1722a D8 Questions I

Aaron Gelter
March 24, 2014

Figure 5.1. AVTPDU common header fields

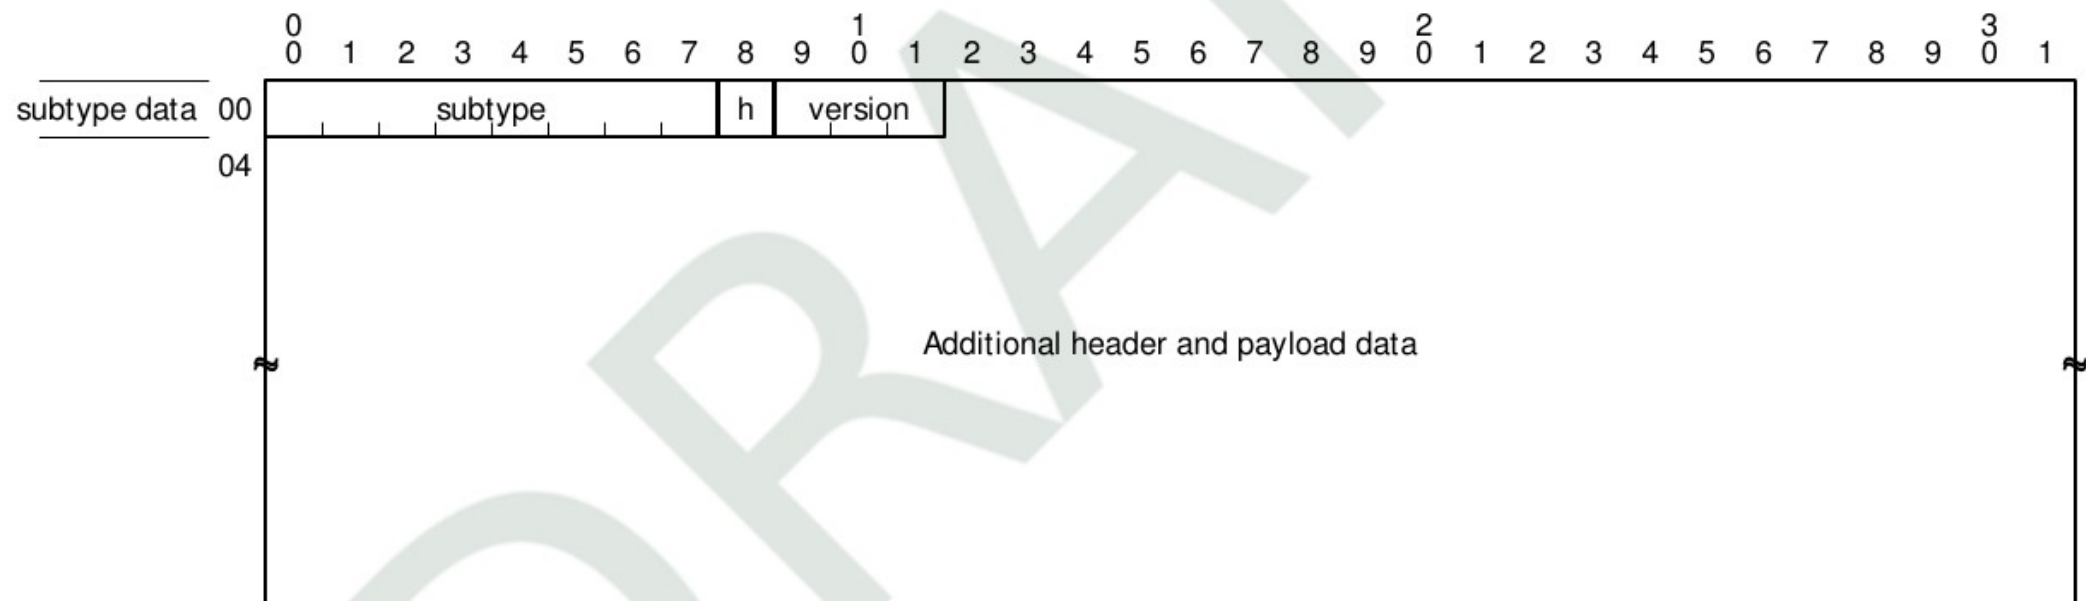
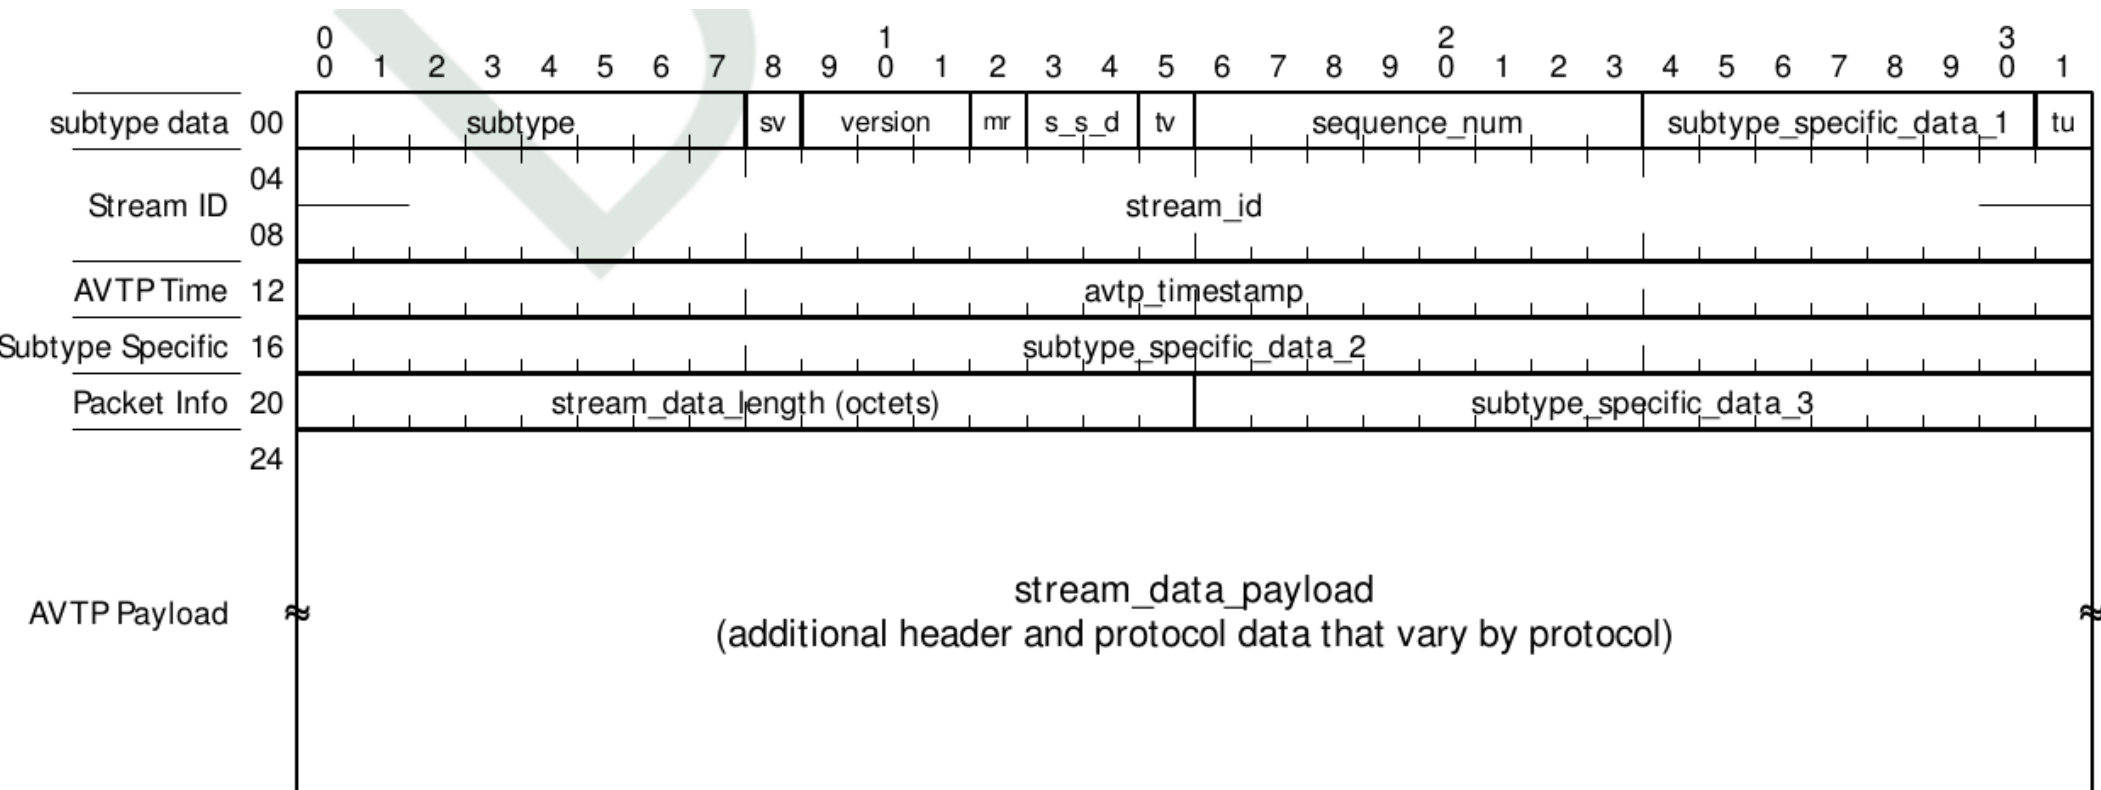
Date	Comm #	Name	Category	Page	Subclause	Line	Comment	Proposed Change	Disposition Status	Disposition Detail
2/20/2014	D7-277	Rakoslaw Kudaj	Technical	11	5.2.2.2	6	<p>Ignoring version field on receive side is inconsistent with AVnu test expectation which says that listener should not record data when AVTP version number is not 0. See Avnu document: AVnu Alliance Pro Audio End Station Certification Program Test Plan for IEEE 1722. Test AVTP.c.2.1 – 1722 Listener Pro Audio Baseline Format Support. Part B.</p> <p>The above refers also to page 12, line 31.</p>	<p>The version field specifies the version of the subtype. This field shall be set to zero (0) on transmit and shall be verified to be 0 on receive.</p> <p>Or</p> <p>Leave line 6-7 as it is and in section 6.2 IEC 61883/IIDC Stream Data Encapsulation add explicit definition as follows: The version field specifies the version of the 61883_IIDC AVTPDU. This field shall be set to zero (0) on transmit and shall be verified to be 0 on receive.</p>	Revise	<p>Version field is moving to the common header. Use definition from 1722-2011. It needs to say that versions are defined by the subtype.</p> <p>NOTE: I don't remember what we decided here. Does each subtype need to now say what version it is? Doesn't that defeat the purpose of having it in the common header? I thought that's why we had the "Unless explicitly defined by the subtype..." verbiage?</p>

Figure 6.3. CIP header and data fields, tag = 1, SPH = 0

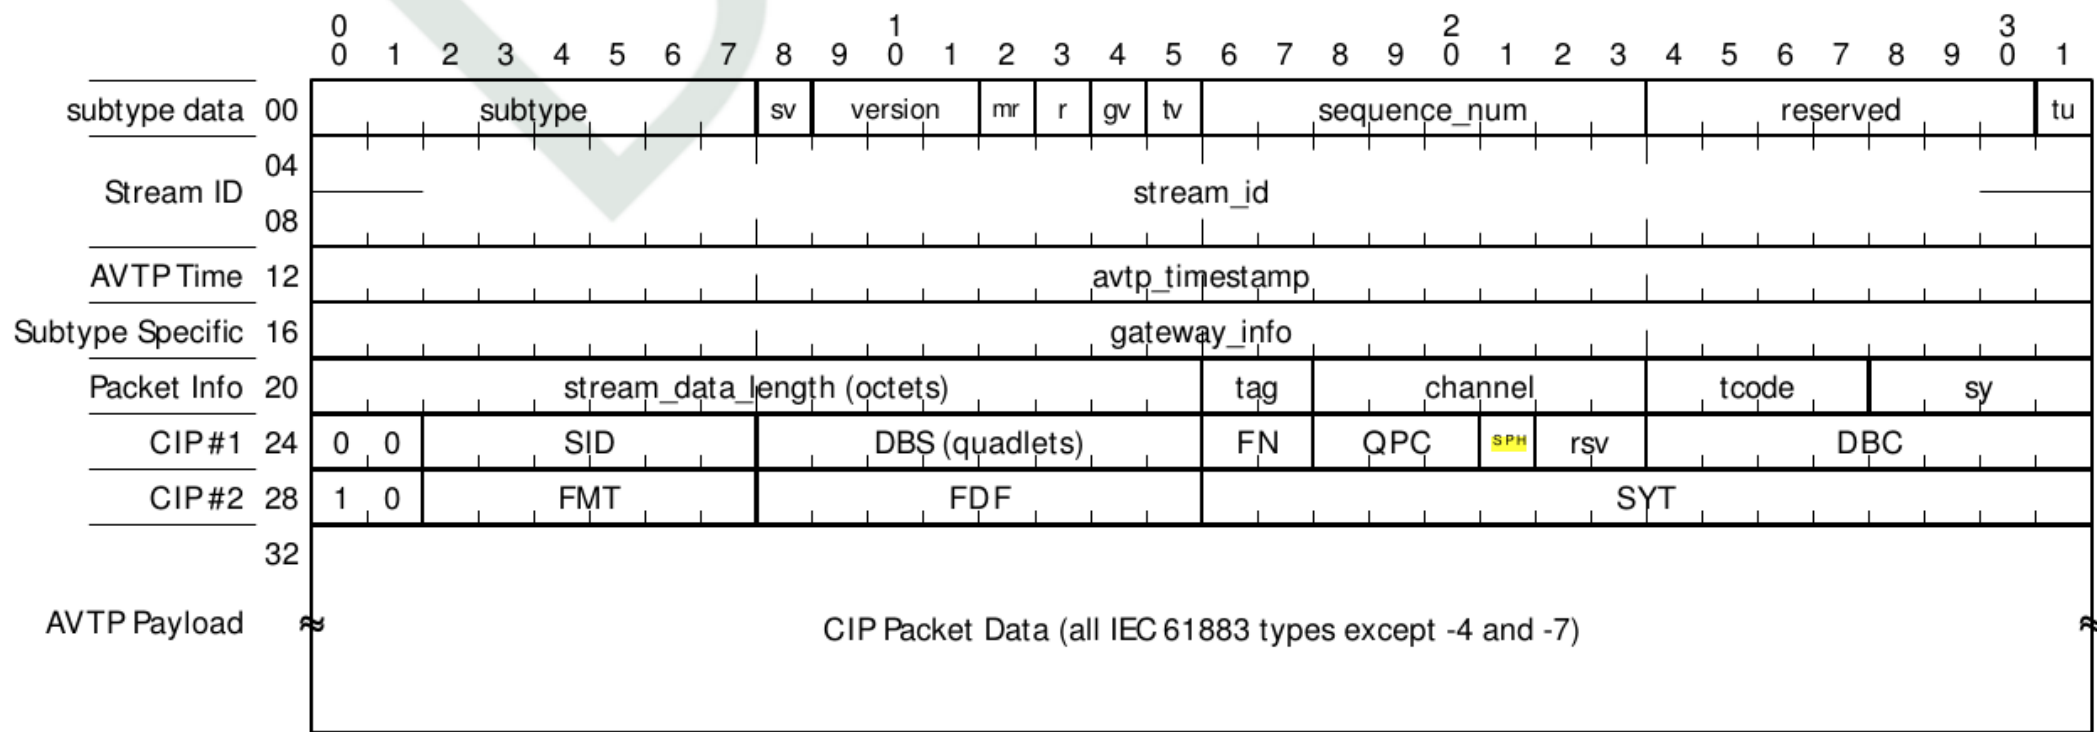
Comm #	Name	Category	Page	Subclause	Line	Comment	Proposed Change	Disposition Status	Disposition Detail
D7-213	Don Pannell	Editorial	19	6.2	33	SPH (0) is too small	Not sure how to fix this easily. Maybe just call the field 'S' and then later define 'S' to map to 61883's SPH?	Revise	Workgroup decided to remove static number designation in diagrams and to remove graying of fields (see D7-29). NOTE: still very small with static assignment removed, need to discuss.
